Published date	06/21/2016
Document number	SUPAIR_2016/06_002
Page number	1 / 4

SAFETY WARNING

SUBJECT : Chest strap's Safe-T buckle
inadvertently opening in flight

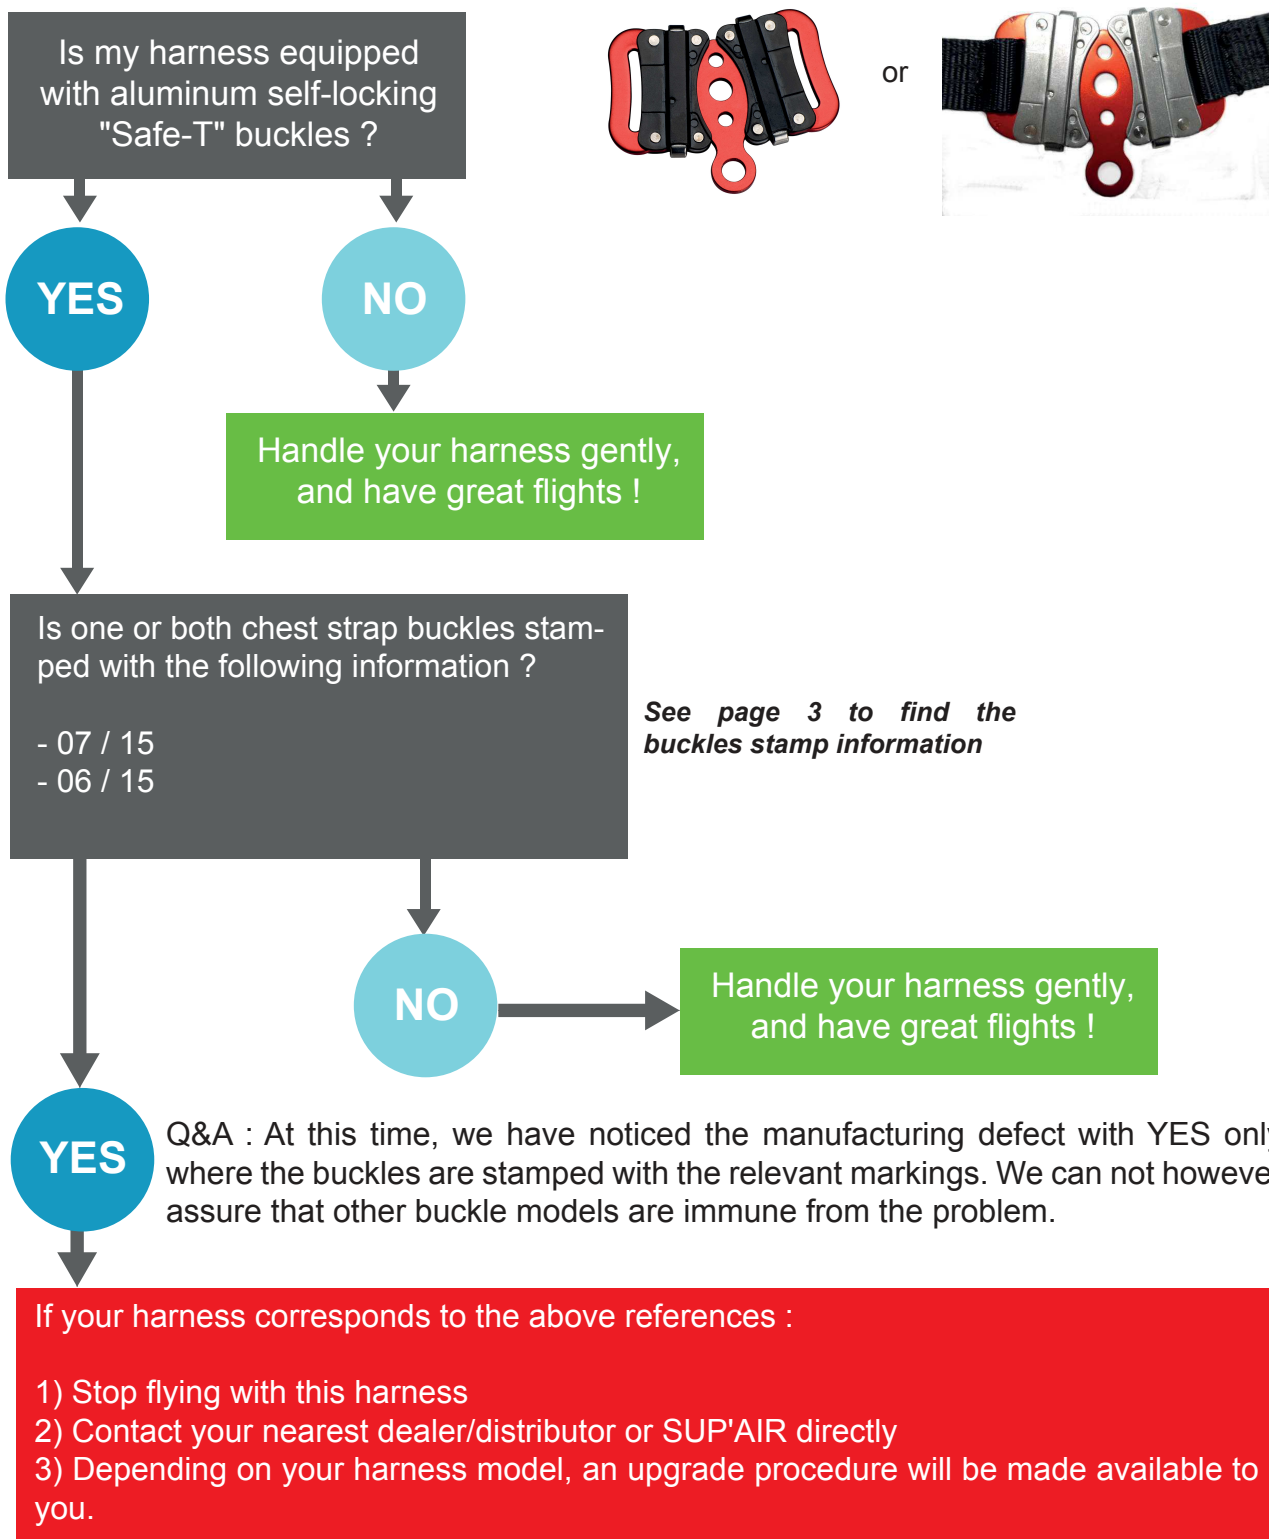
Procedure to follow :

How to identify if my harness is concerned ?

Where to find the self-locking buckles stamp information ?

- **Stop flying with the problem harness.**
- Fill out the form " Self-locking chest strap buckle - swapping/upgrade procedure" (see below).
- Contact your dealer or distributor who will help you with the steps to follow :
